WESTERN INTERNATIONAL OFFICE BUILDING
 15275 QUORUM DR.
 ADDISON, TX 75001

Revisions:
09 21 2018 PERMIT ISSUE
 9/27/2018 - ADDENDUM #1
 CIVIL COMMENTS

SHEET NO.
C5.00

STORM SEWER PLAN						
WESTERN INTERNATIONAL OFFICE BUILDING						
WESTERN INTERNATIONAL						
MAYSE & ASSOCIATES INC.						
TOWN OF ADDISON, TEXAS						
DESIGN	DRAWN	DATE	SCALE	XREF	FILE	NO.
RLG	RLG	9/27/18	1"=20'	1813.013	1813	013
JOB NO.	SUBMITTAL:					
1813.013

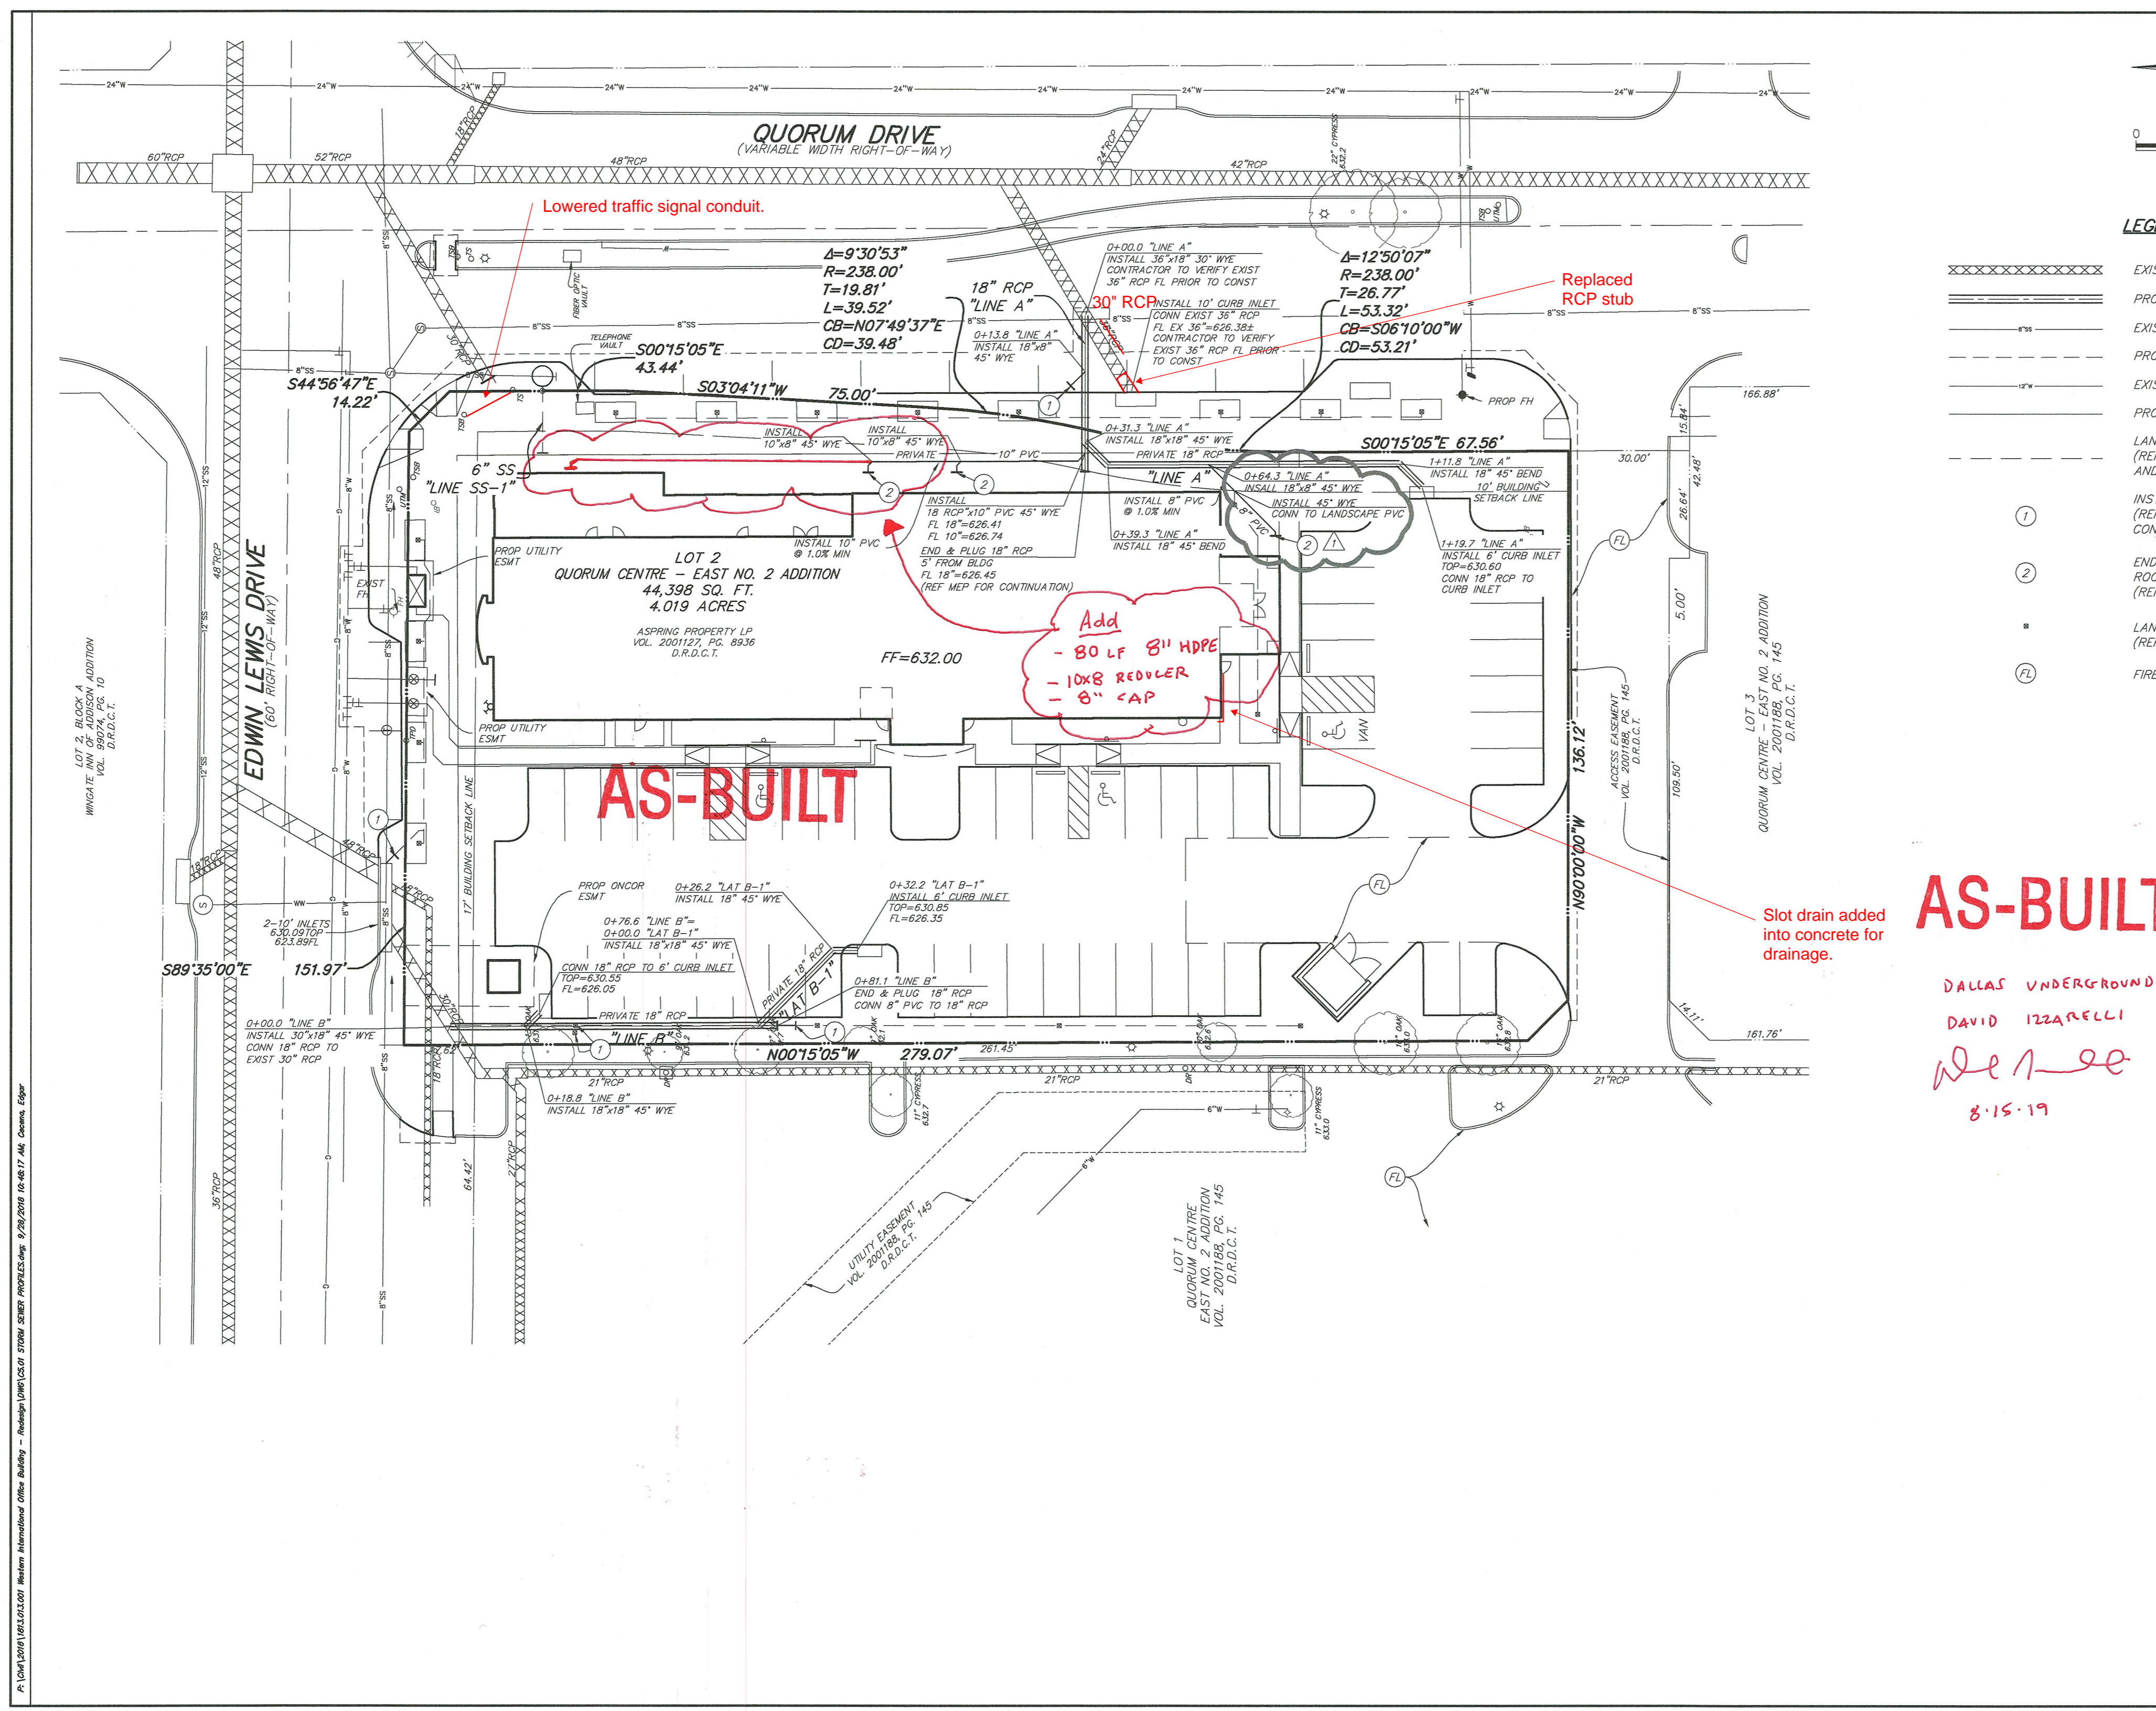
Slot drain added into concrete for drainage.

Add
 - 80 LF 8" HDPE
 - 10x8 REVDLER
 - 8" CAP
